AGENDA

HISTORIC DISTRICTS REVIEW
BOARD
OCTOBER 08, 2024
5:30 PM
CITY COUNCIL CHAMBERS
CITY HALL
200 LINCOLN AVENUE

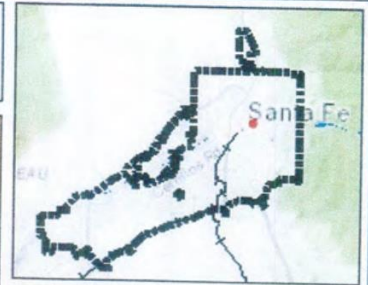
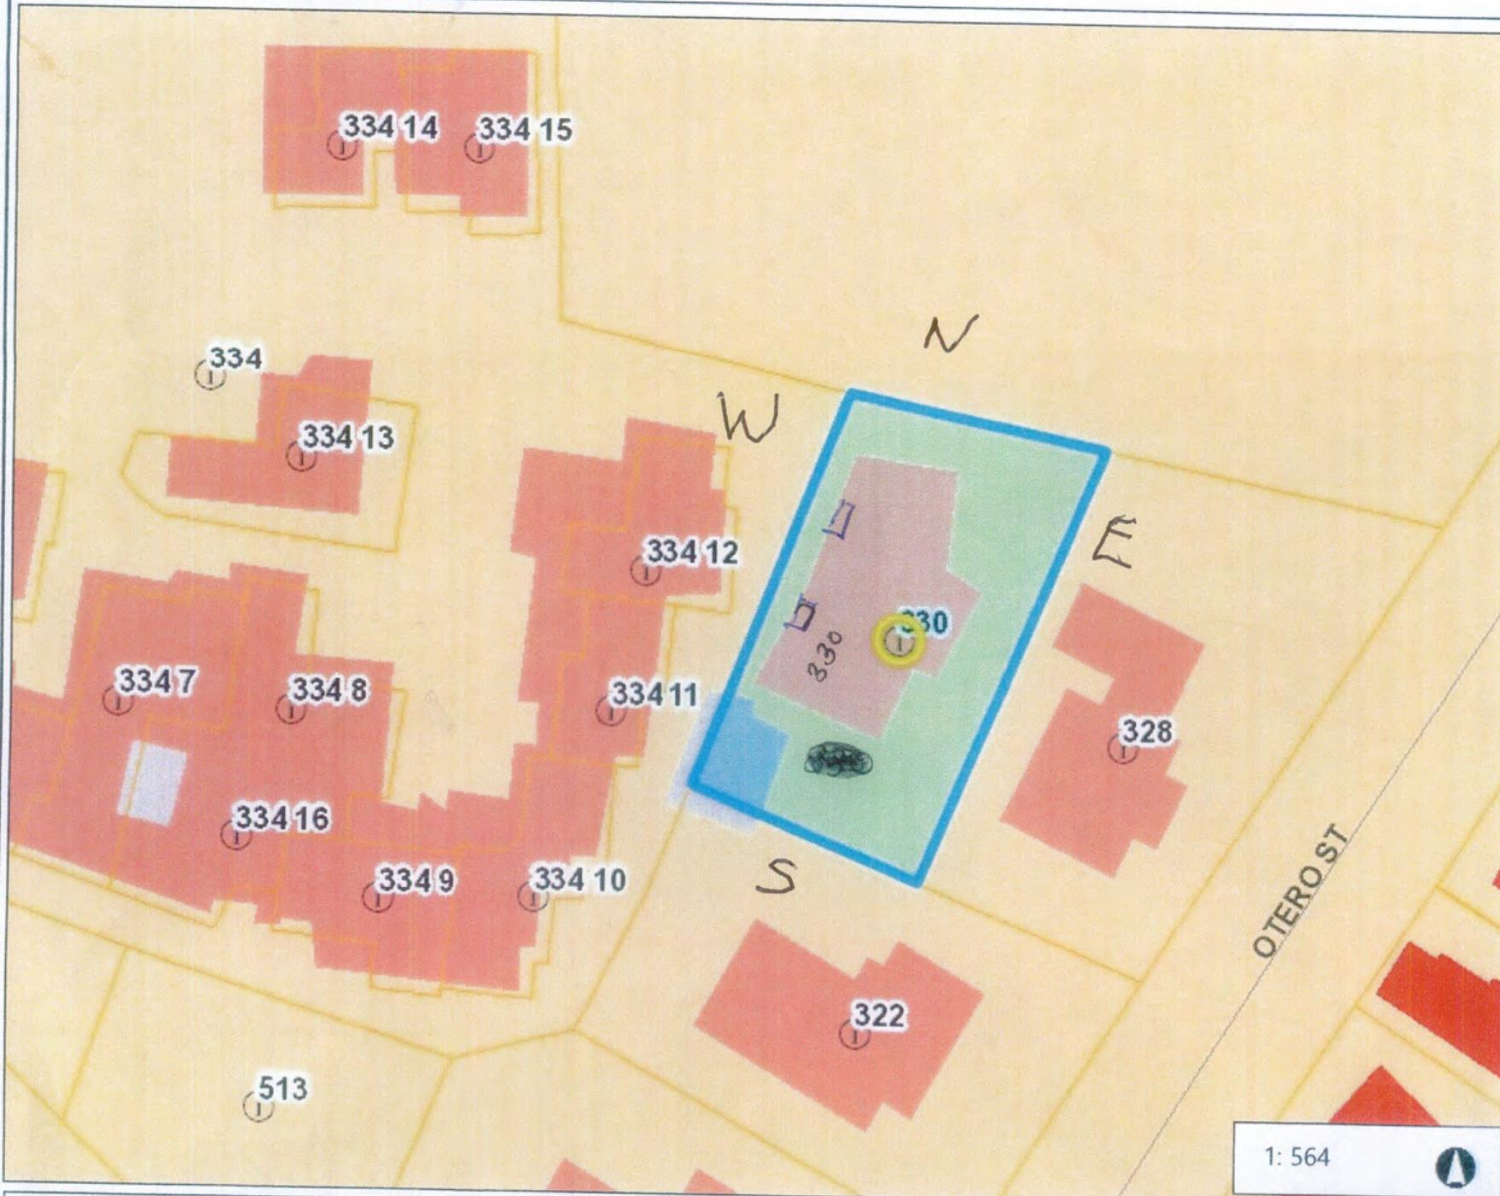
Response: The existing windows are leaking and allowing water to infiltrate the house. This has caused the framing of the wall to rot. This is causing movement of the windows and the plaster inside the home to be destroyed and the exterior stucco to crack. The windows leak air and are not at all energy efficient creating the hardship of high energy costs and a cold home. If no action is taken the home will be severely damaged.
